Validation report form for  
Gold Standard Project activity

<b>Title of the Project Activity (PA)</b>	Jintai Animal Manure Management System GHG Mitigation Project
<b>GS Reference Number</b>	GS-12048
<b>Version number of the validation report</b>	1.0
<b>Completion date of the validation report</b>	13/11/2023
<b>Version number of PDD to which this validation report applies</b>	Version 04, dated 17/10/2023
<b>Start Date of PA</b>	21/12/2021
<b>Project Participant</b>	Henan Deneng Energy&Environmental Protection Technology Co., Ltd.
<b>Host Party</b>	China
<b>SDG Targeted:</b>	1.SDG 8: Decent work and Economic Growth (8.5.1) 2.SDG 12: Responsible consumption and production (12.5.1) 3.SDG 13: Climate Action (13.2)
<b>Applied methodologies and standardized baselines</b>	ACM0010 "GHG emission reductions from manure management systems" (Version 08.0)
<b>Mandatory sectoral scopes</b>	1 and 13
<b>Activity Requirements applied</b>	Community Services Activities
<b>Product Requirements applied</b>	GHG Emissions Reduction & Sequestration Product Requirements (Version 2.0)

<b>Name and UNFCCC reference number of the VVB</b>	E-0052: Carbon Check (India) Private Limited
<b>Name, position and sign

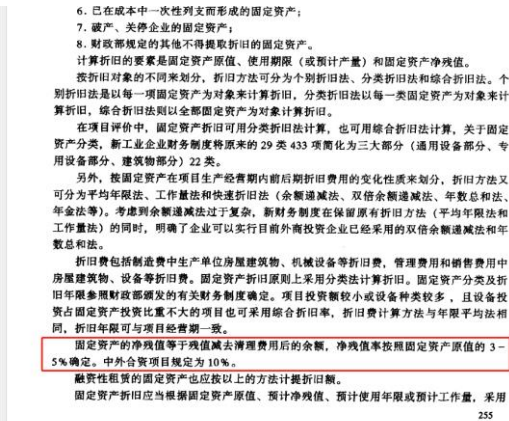
3. In the flow chart, it is mentioned that produced biogas will be used for power generation and flaring. The same is not mentioned in the description of the project. Further, in section A.3, under comprehensive utilization of biogas process, it is mentioned that biogas is used for heating and power supply. PP is requested to clarify what exactly the biogas is used for. And make the details consistent across the PDD.

2. In Ex-Ante estimation, it is assumed that all the collected biogas is used to provide hot water, and no biogas is burned by the flare, so the emission from flaring or combustion of the gas stream is not considered in the project boundary. Please review.

3. Before the construction of the project, it was originally intended to use the biogas generated by the anaerobic digestion for power generation. However, in the actual operation process, the biogas generator has not been put into use. The biogas is only used for short-term ignition during the annual equipment inspection, and it has been determined whether the equipment is in good condition. The biogas generated during the treatment process will be captured for hot water generation, and the residual biogas will be flared by internal combustion emergency flare (closed flare) if there is any surplus biogas. The relevant expressions have been unified in the project design document. PP has made the details consistent across the PDD, please review.

The justification provided by the PP is found to be appropriate and acceptable. Further PP has revised the utilization of biogas as per the actual scenario and the same is consistent across the PD. Hence, CL 05 is closed.
